Docket Number:	97-AFC-01C
Project Title:	High Desert Power Plant
TN #:	220705
Document Title:	Energy Commission Staff's Proposed Stipulation Language For The High Desert Power Project (HDPP, 97-AFC-01C) Recycled Water Use
Description:	N/A
Filer:	Marichka Haws
Organization:	California Energy Commission
Submitter Role:	Commission Staff
Submission Date:	8/11/2017 4:20:50 PM
Docketed Date:	8/11/2017

Subject: ENERGY COMMISSION STAFF'S PROPOSED STIPULATION LANGUAGE FOR THE HIGH DESERT POWER PROJECT (HDPP, 97-AFC-01C) RECYCLED WATER USE

Figure 1 Total monthly water use and recycled water percentage in 2014

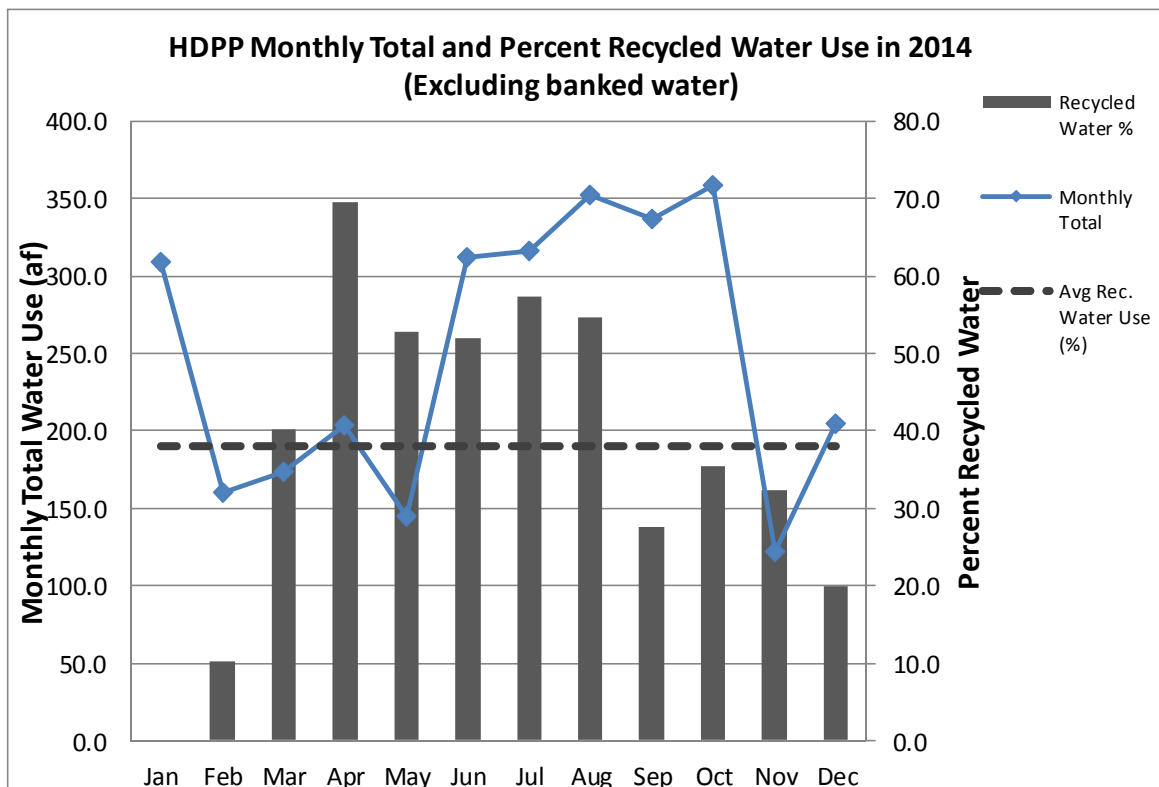
As shown in Figure 1 below for calendar year 2014, in the middle of the recent California drought, the project used about 3,000 AFY of water for process cooling, of which, 38 percent or about 1,140 AFY was recycled water.

- a. In August 2014, a month with a high capacity factor and water use, the project achieved 60 percent of its monthly process water use as recycled water.

- b. In 2014, there were months (see figure below) where the project used more than 50 percent recycled water, including periods where the project was operating with both a high capacity factor and high water demand and low capacity factor and low water demand.

In an effort to facilitate a negotiated agreement between the parties, staff is proposing edits to HDPP condition SOIL&WATER-1 as shown in the attachment, that agree to a minimum annual recycled water use of 20 percent. Since staff is willing to agree to 20 percent, which is readily achievable, staff is recommending modification of the chlorine injection system and incorporation of a loading sequence, discussed below, to ensure available recycled water is used.
